Annex 5: Customer declaration: HW change description v1.2 to Test Report 20-1-0017101T02a-C1

1 LOCU1xxx HW change description v1.2

Hardware change description
SICK LOCU1xx – UWB TAG

v1r3 -> v1r3.1 change description

Details for changes of LOCU Battery Basic/Advanced bottom layer:

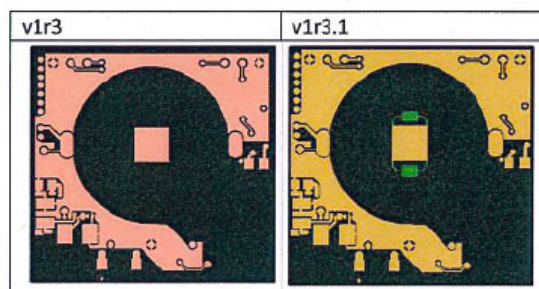
1. Battery holder: Pad adjustment of negative battery contact- milled grooves for battery holder are shifted in v1r3.1 comparing to v1r3. The pitch of grooves is increased by 0,45 mm.

- red mark - v1r3
- green mark - v1r3.1
